Design Review Subcommittee (DRSC)

Meeting Date: March 13, 2019

SUBJECT: **Site Plan Permit (SPP) 18-663 / Cultural Heritage Permit (CHP) 18-664, North Beach Bed & Breakfast**, a request to construct a Bed and Breakfast Inn with one primary residence and three guest rooms within the NC2-A-AH-CZ zone at 1410 Calle Mirador.

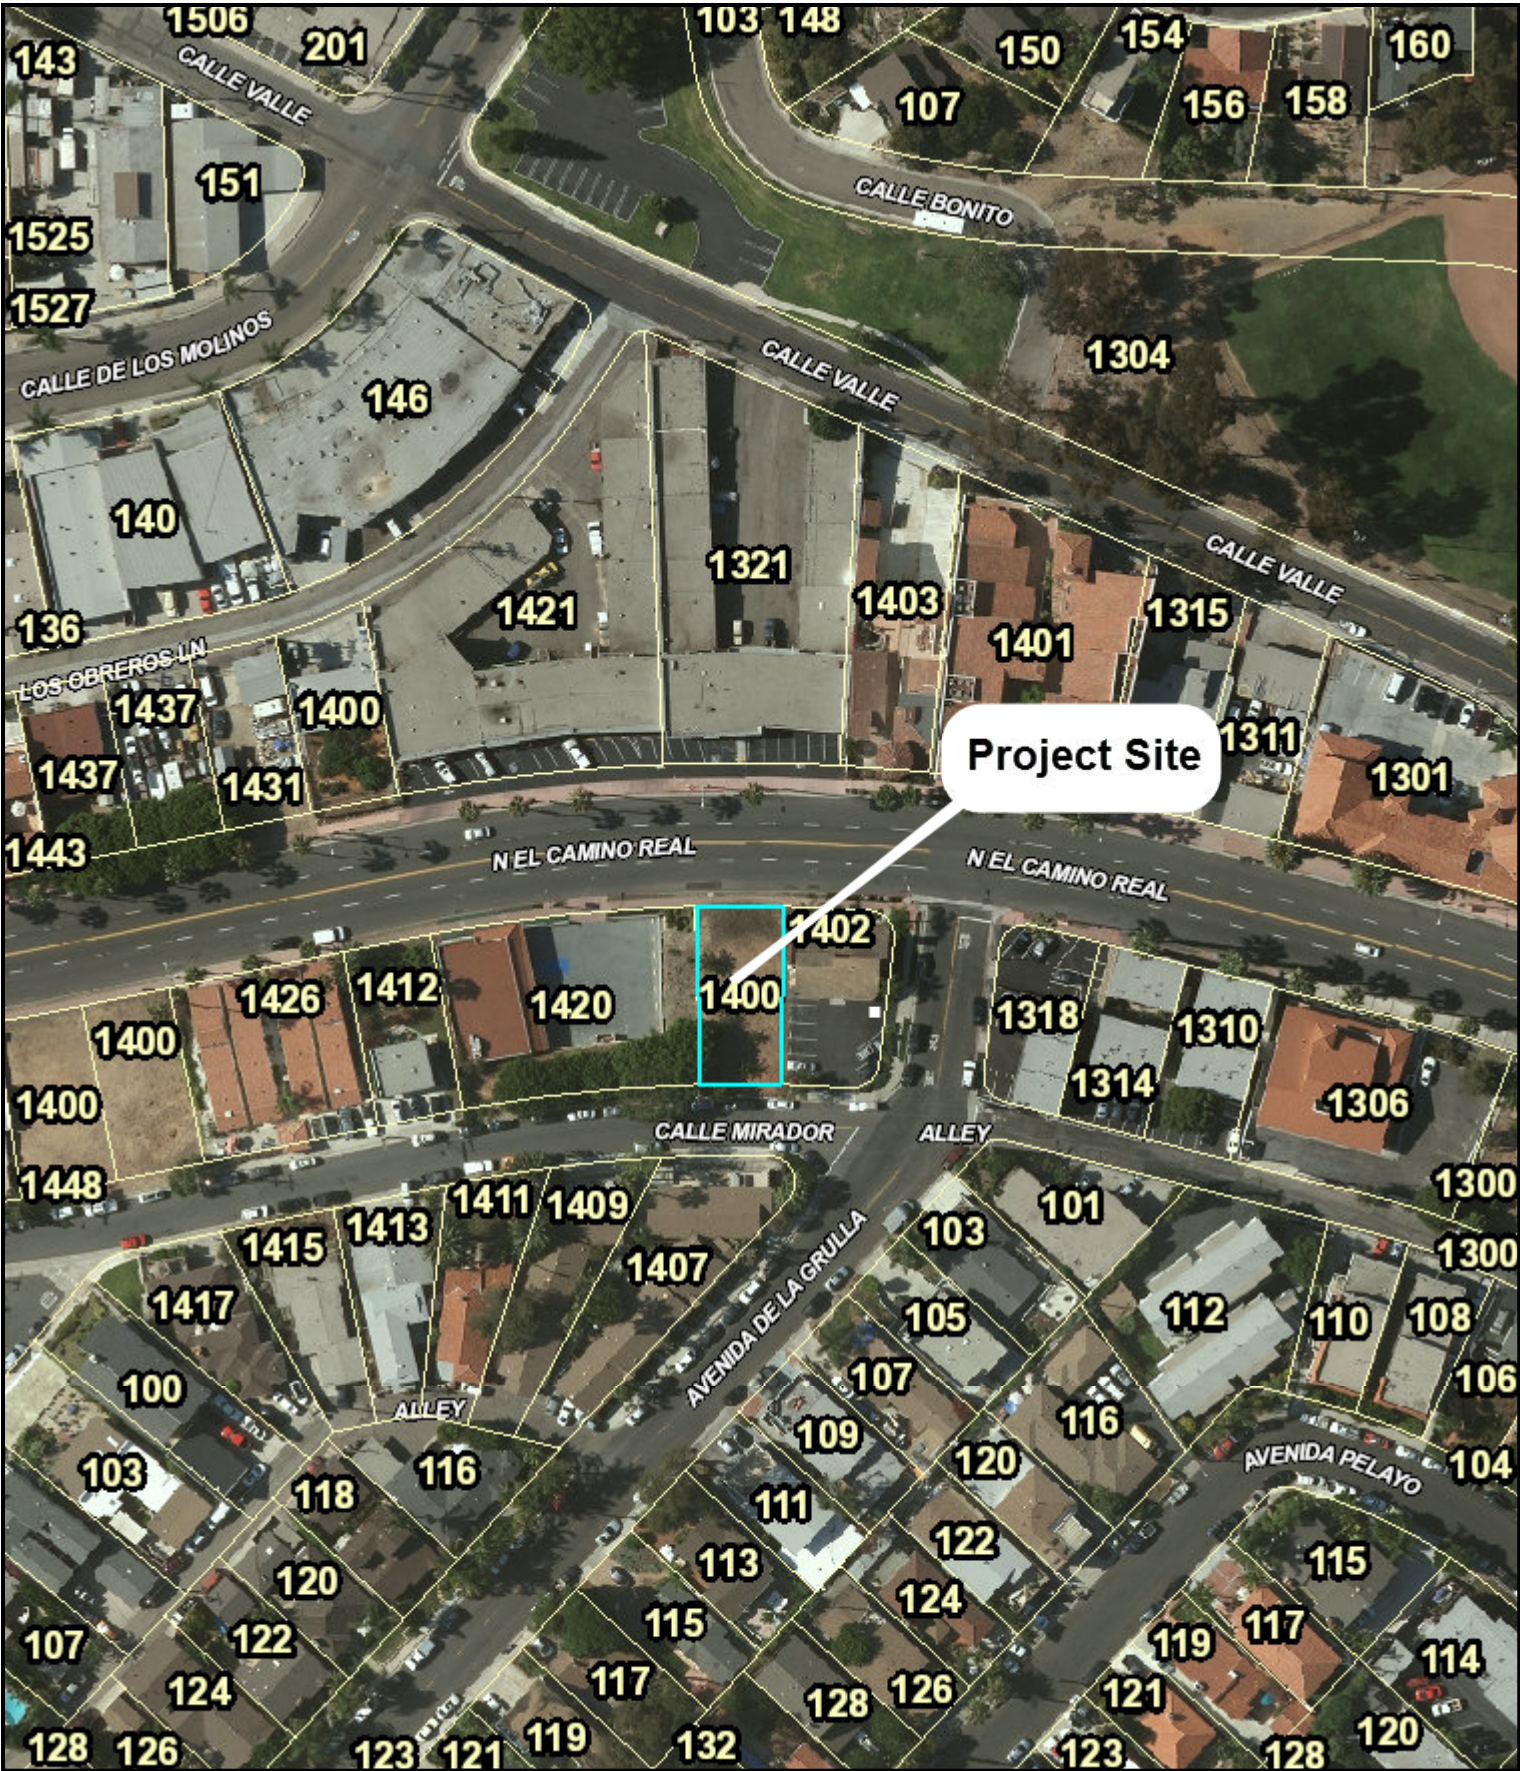
To improve the project’s consistency with the Design Guidelines, staff recommends the following modifications (with visual samples provided in Attachment 2) for greater architectural quality and consistency with the Design Guidelines.:

1. Utilize an arched trellis within the stucco recess on the left elevation.
2. Use larger shutters to match the size of the windows or use an alternate detail such as an awning if needed to maintain spacing on the elevations. Arched shutters would be an attractive addition on the El Camino Real elevation.
3. Identify the type of metal clad windows intended for use as well as the type of light fixtures within a sample materials sheet. The awnings are indicated as a charcoal color. Staff prefers that the awnings use one of the green accent colors from the color palette instead as colorful awnings are more typical for SCR residences.
4. If necessary, submit a Minor Exception Permit to allow the retaining wall that is supporting the driveway. The proposed retaining wall appears to exceed six feet in height. This comment was provided during the Design Management Team (DMT) review.
